Name: Marcy Cochlan Organization: TransAlta

Date: February 27, 2018

CMD Key Design Questions	Comments and / or Recommendations
UCAP: Can you support the availability factor/capacity factor over the 100 hours of smallest supply cushion being used to calculate the UCAP?	No – determination of availability factor using the 100 hours of smallest supply cushion over the past 5 years to calculate UCAP creates unfair treatment for existing generators and unnecessarily increases costs to consumers. Specifically: • It is discriminatory to existing generators. It is not consistent with the principle of fair treatment for new and existing resources because it disadvantages existing assets. Use of 5-year historical availability arbitrary assesses existing asset performance under a different electricity market structure that did not provide the same availability incentives as the current market structure, whereas new assets will be assessed on a forward-looking basis, meaning that existing assets would be retroactively penalized through a lower UCAP value that is unreflective of an asset's actual reliability contribution. • It does not assign risk to the participant that is best suited to mana

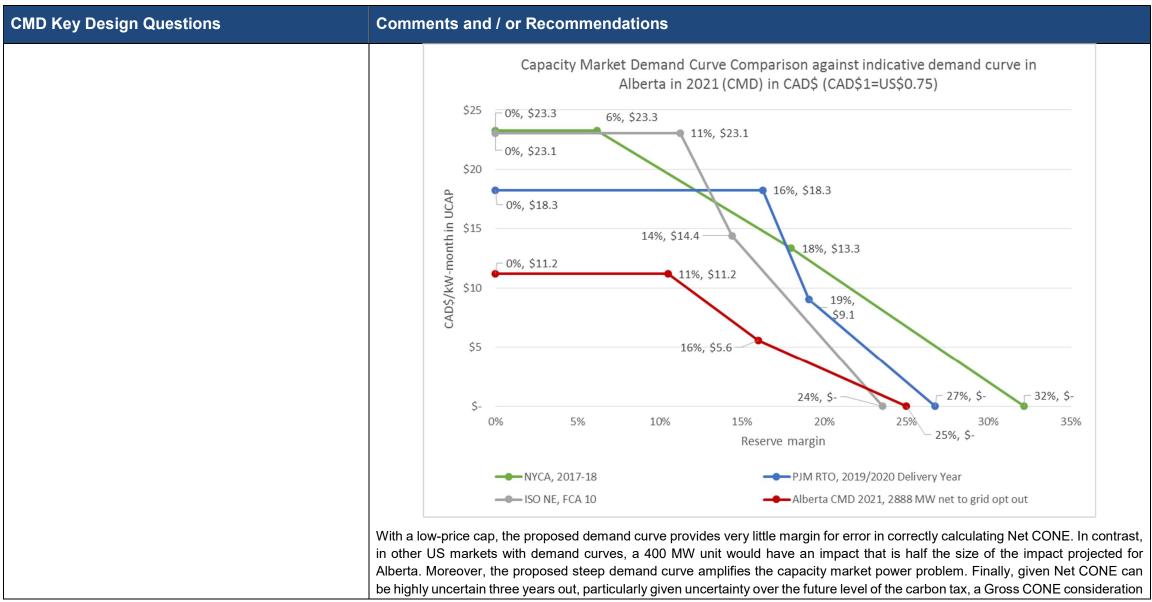
TransAlta also has deep concerns about the shape of the demand curve and the unintended consequences it creates given the size of the Alberta market relative to the size of a typical generation unit. The choice of a low-price cap, inflection point, and short foot creates a noticeably shorter, narrower, and steeper curve than demand curves used in other capacity markets – see below:

Rather, we believe that the demand curve should contain the following features:
	 A higher price cap – given uncertainty over energy and ancillary service revenue calculations three years out, the AESO should adopt a curve capped at the maximum of 1xGross CONE or 1.75x Net CONE to account for the possibility that AESO may err on the Net CONE estimation or that Net CONE values will drop based on future energy market expectations. A longer foot – a foot that extends to a 35% reserve margin is necessary to safeguard resource adequacy as Alberta moves through the market design transition to prevent premature retirement, mitigate high capacity price volatility, and provide a stable investment price signal.
